Agenda
Village of Arlington Heights
Zoning Board of Appeals
Buechner Room, 1st floor

Arlington Heights Village Hall
33 S. Arlington Heights Road
Arlington Heights, IL 60005
January 8, 2018
7:00 PM

- A. 1176 N. Beverly Ln. - ZBA#17-059
- B. 2914 N. Mitchell Ave. - ZBA#17-060
- C. 935 N. Haddow Ave. - ZBA#17-061
- D. 1301 N. Illinois Ave. - ZBA#17-062
- E. 2101 S. Arlington Heights Rd. - ZBA#17-063

WEST ELEVATION
SCALE: 1/4" = 1' - 0"

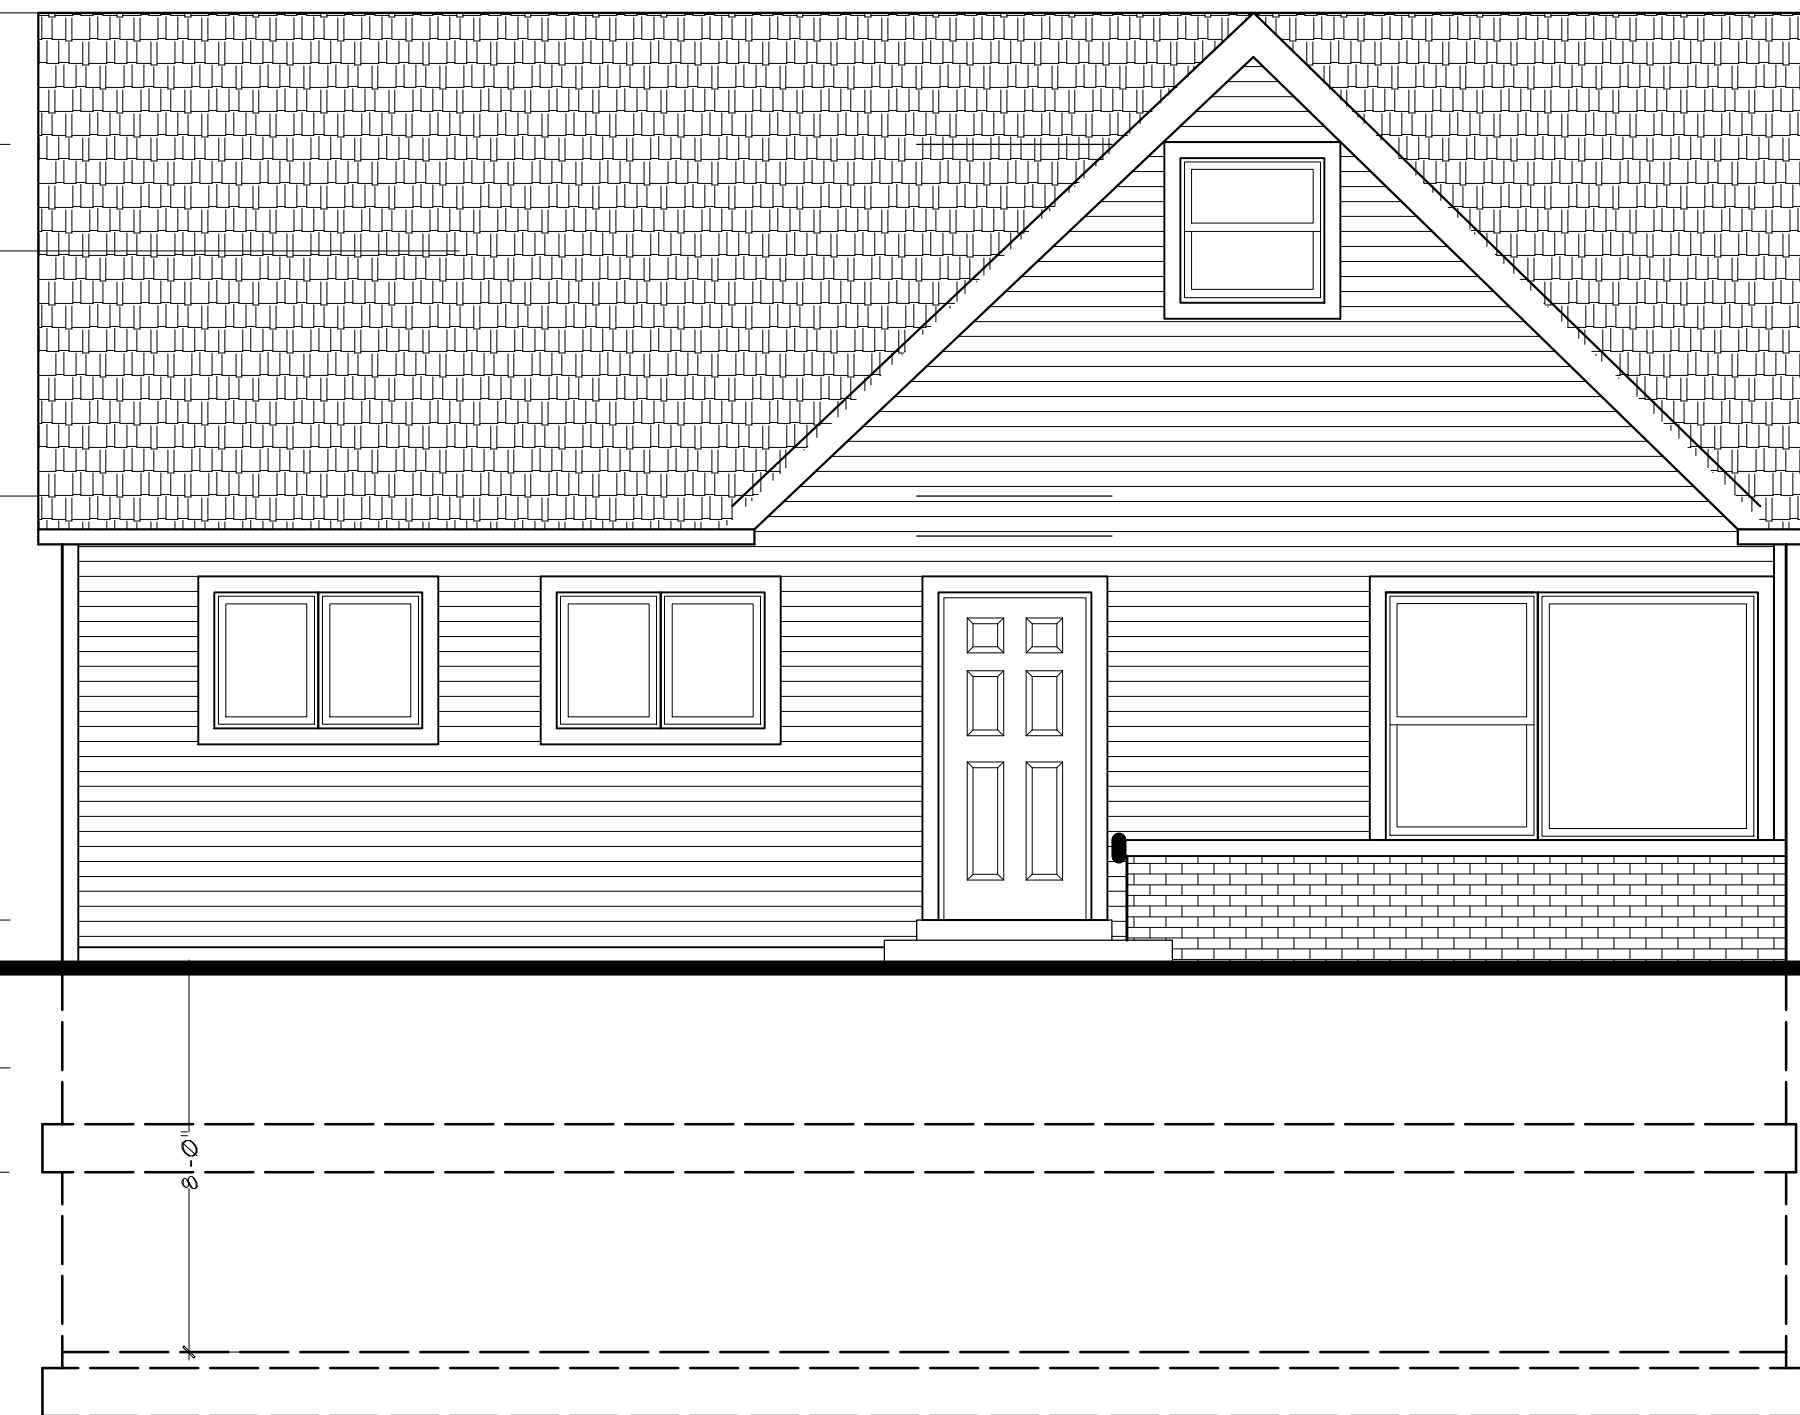
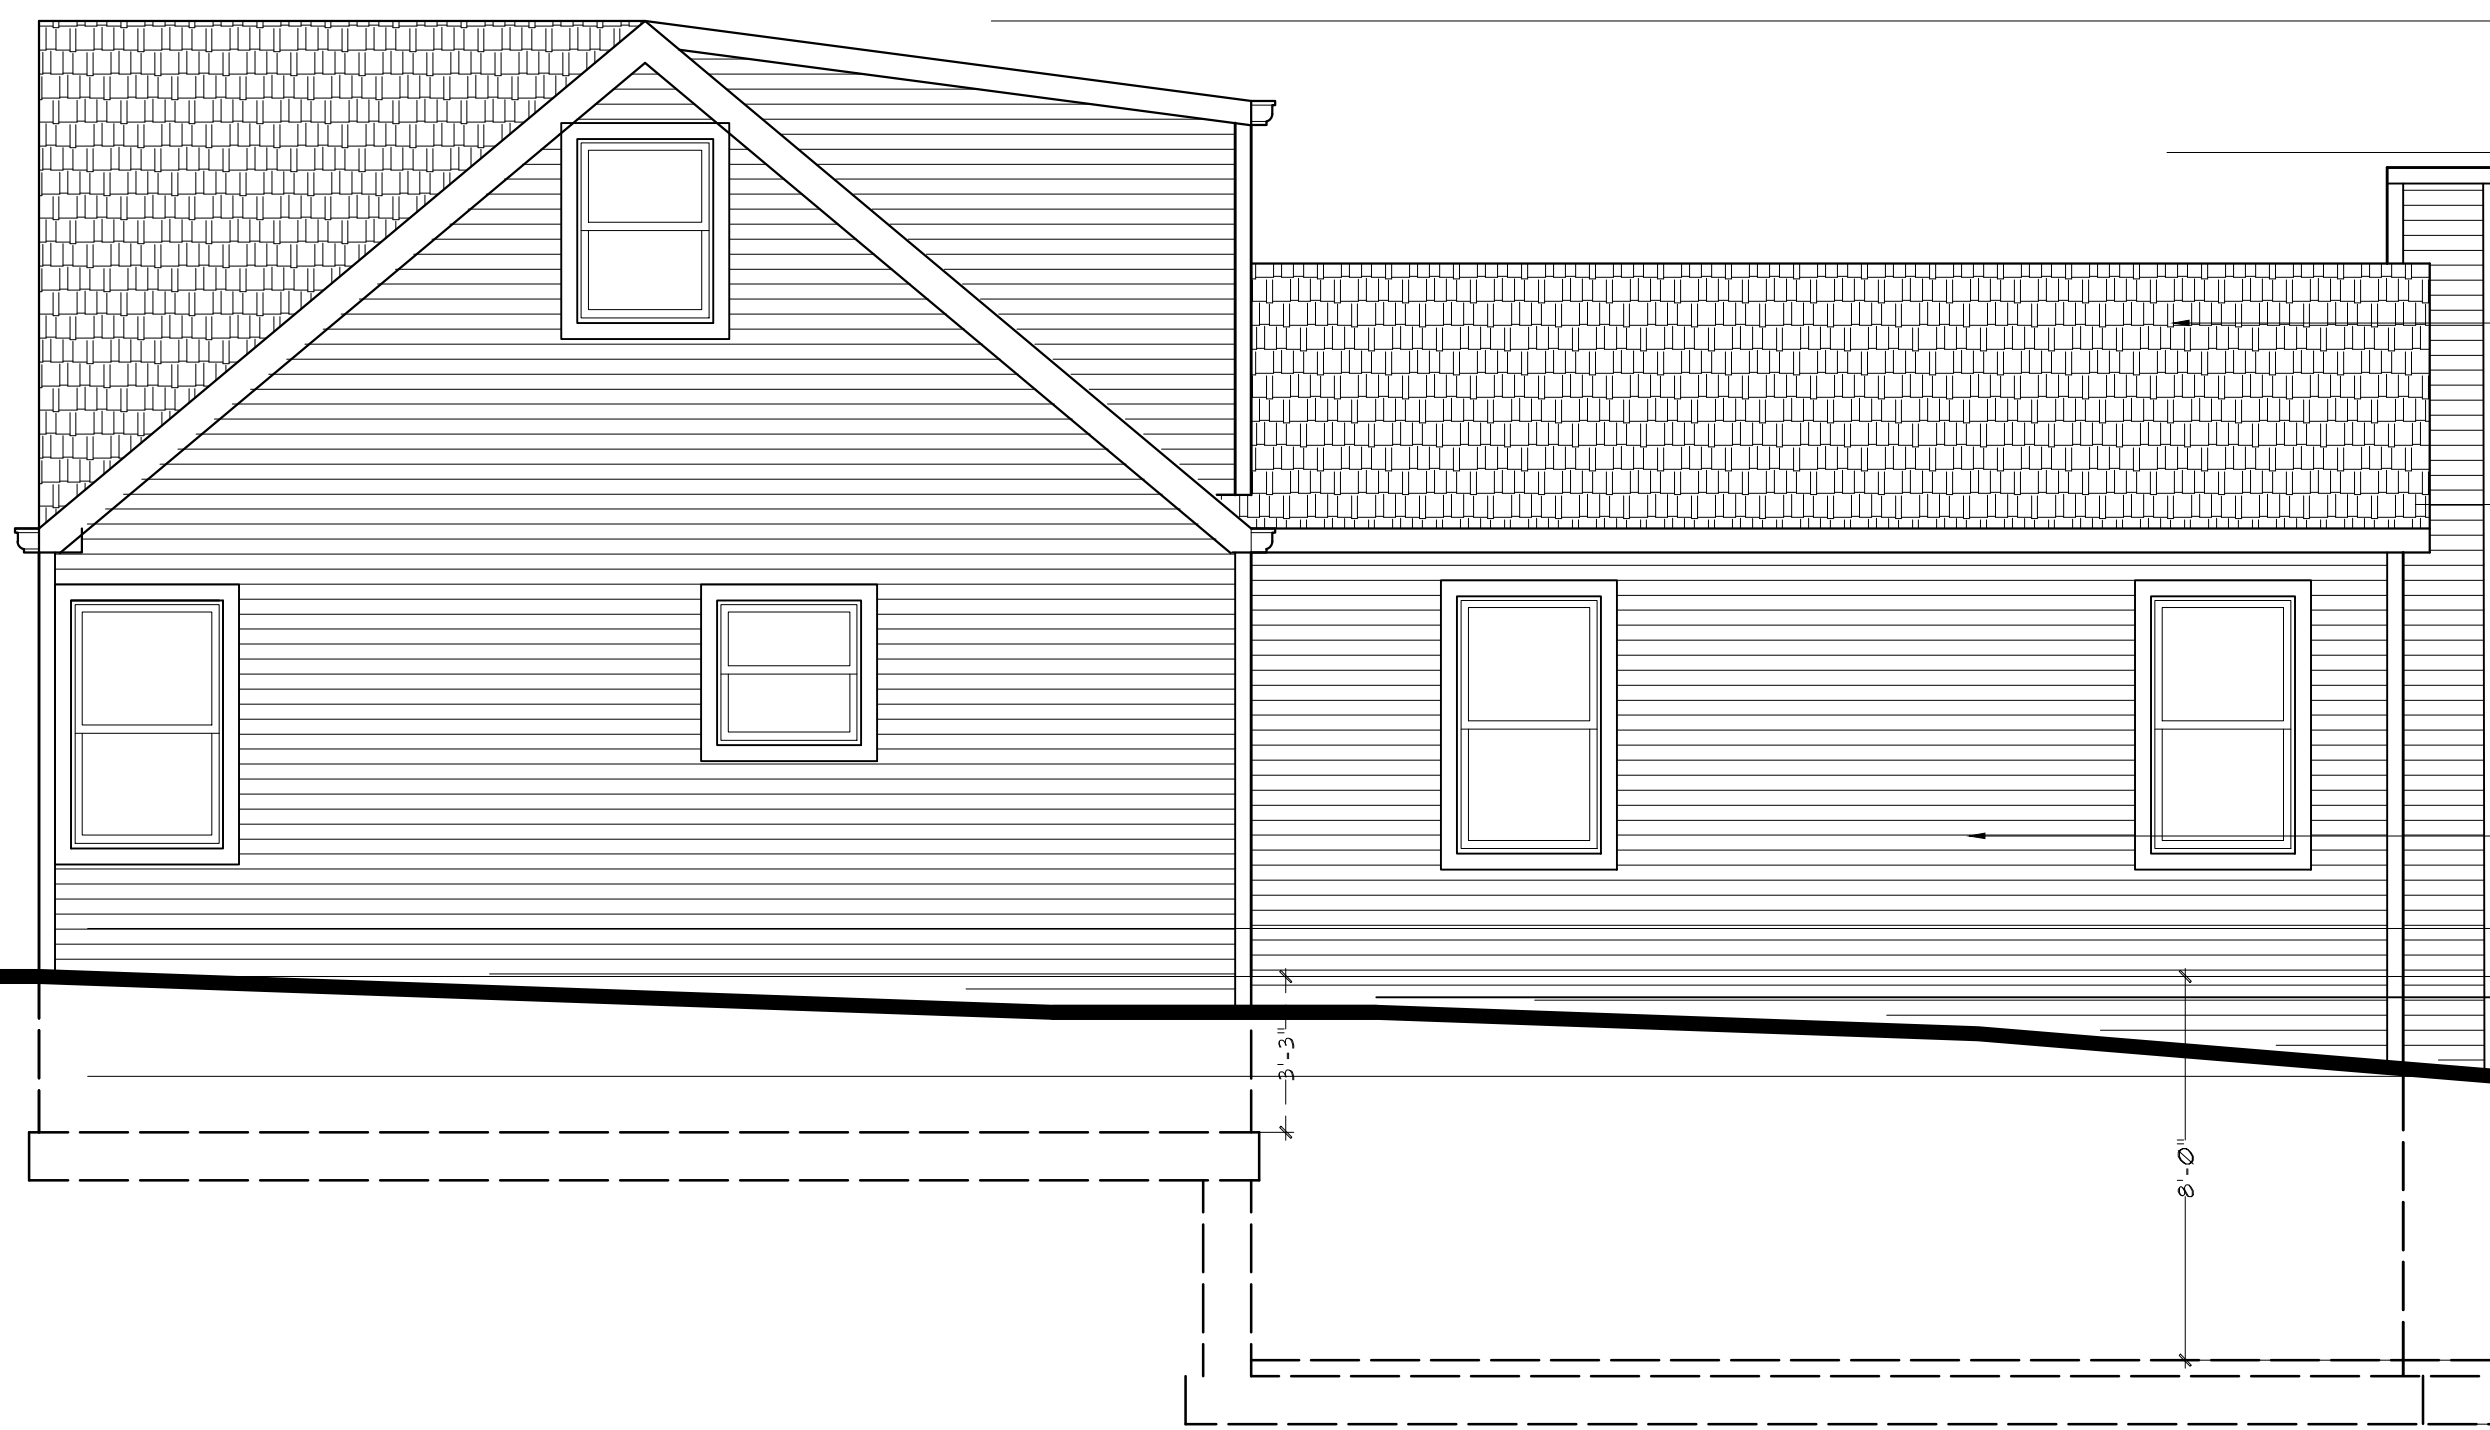
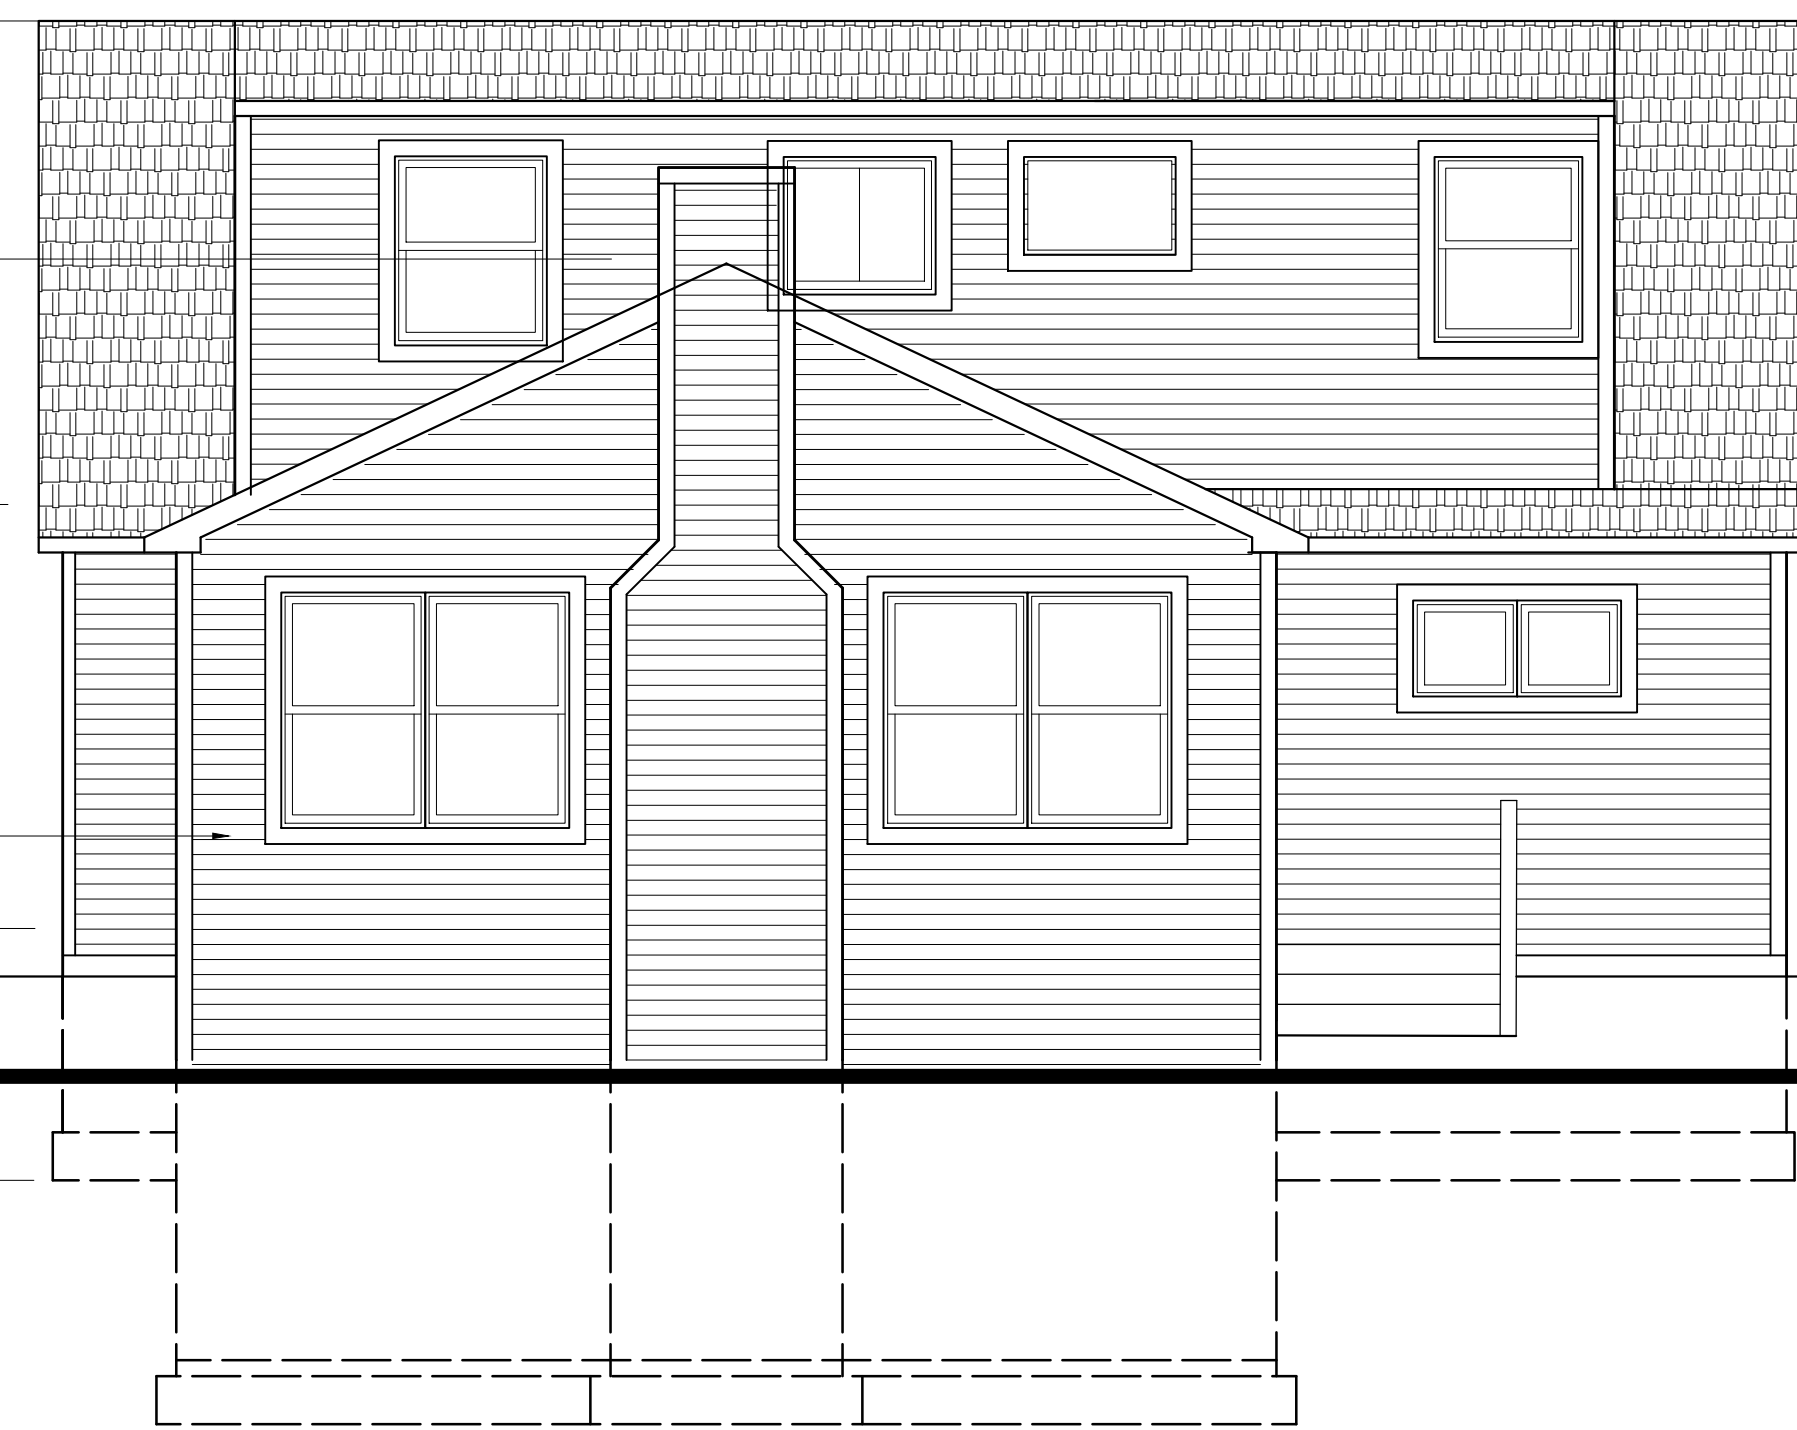
The plans for the addition show a window well in the south side yard. The window well as shown would be less than 2 ft from the south property line and would not meet code. The petitioner has been made aware of the minimum setback required for window wells and has indicated they will revise their plans to relocate the window well.
